**CITY OF AUSTIN APPLICATION TO BOARD  
OF ADJUSTMENT INTERPRETATIONS  
PART I: APPLICANT'S STATEMENT  
(Please type)**

# **Appeal of the City of Austin Administrative Decision on Interpretation and Clarification of Section 3.3.3(C) in Article 3 of Subchapter F**

## PROJECT: 2015 GOODRICH AVENUE AUSTIN, TX 78704

### A1.1

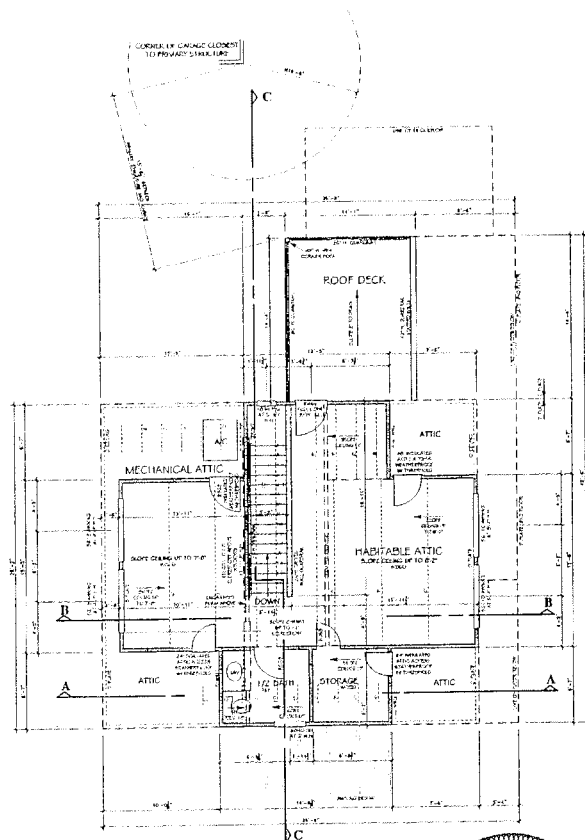
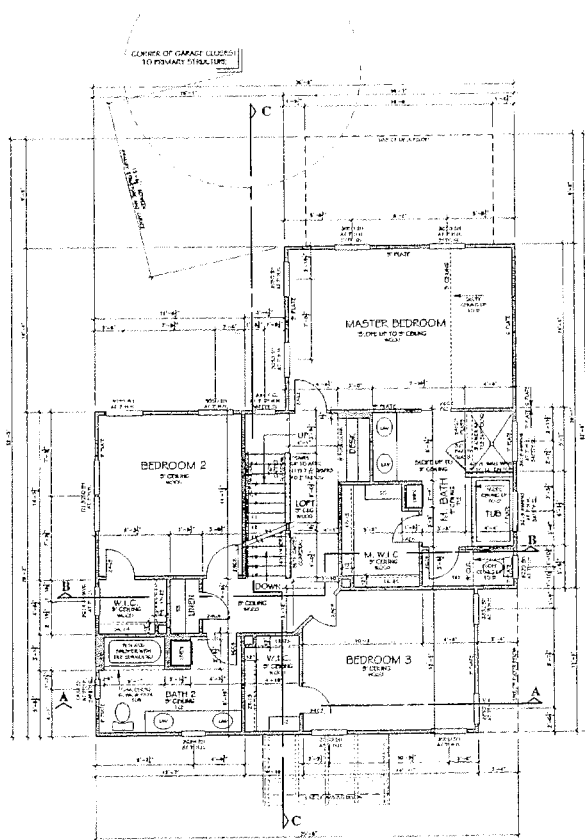
- 2) The architectural plans of the first and second floor (Drawings A1.1 and A1.2) appear to be drawn to the outer edge of the wood framing and not to the "outside surface of the exterior walls" demonstrated by the fact that the first floor plan dimensions (Drawing A1.1) match the foundation plan dimensions (Drawing S-1). Normally, the edge of the framing is aligned with the foundation edge. When sheathing and siding is added, this dimension can increase by an inch or more on all sides. Since the criteria for calculating the McMansion FAR is measurement to the "outside surface of the exterior walls", the McMansion FAR is not calculated correctly. If one assumes a ½" sheathing and ¾" siding, the first floor area is increased to 1,301.6 sf and the second floor area is increased to 1285.3 sf. This is an additional 33.8 sf that must be added to the McMansion FAR calculation.

### ATTIC EXEMPTION PLAN

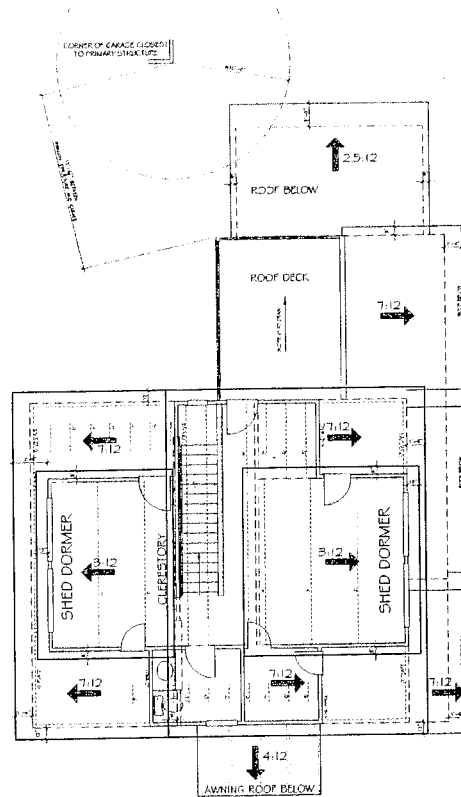
- 3) The attic exemption from McMansion FAR requested by the applicant is not allowable under the McMansion ordinance. The attic exemption is allowable only if it meets certain conditions:

- 1. The roof above it is not a flat or mansard roof and has a slope of 3 to 12 or greater;*
- 2. It is fully contained within the roof structure;*
- 3. It has only one floor;*
- 4. It does not extend beyond the footprint of the floors below;*
- 5. It is the highest habitable portion of the building, or a section of the building, and adds no additional mass to the structure; and*
- 6. Fifty percent or more of the area has a ceiling height of seven feet or less."*

Exhibit "A"

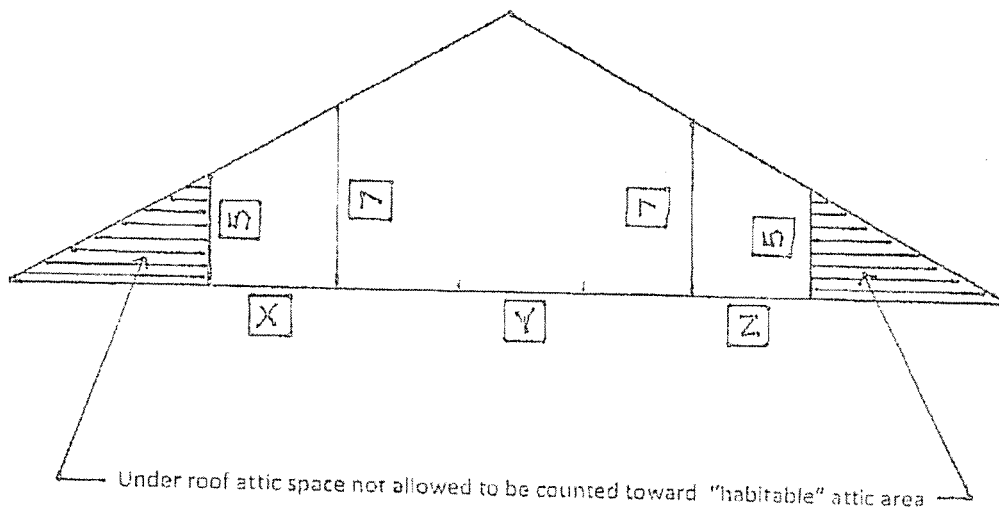
The Board of Adjustment could define "fully contained" and "additional mass" based on Daniel Word's modification of the 2007 Eichert memo (see below), which shows the "under roof attic space not allowed to be counted toward 'habitable' attic area." The four diagrams on the next page illustrate how simple "above-roof" dormers of various sizes could relate to under-roof spaces that are clearly allowed to be counted as habitable attic area.

**Diagram A** Under this interpretation, the habitable attic areas shown in the modified Eichert diagram and in our diagram A are considered to be the maximum area that can be excluded from FAR, as they are clearly contained within the roof structure and do not add any additional mass.
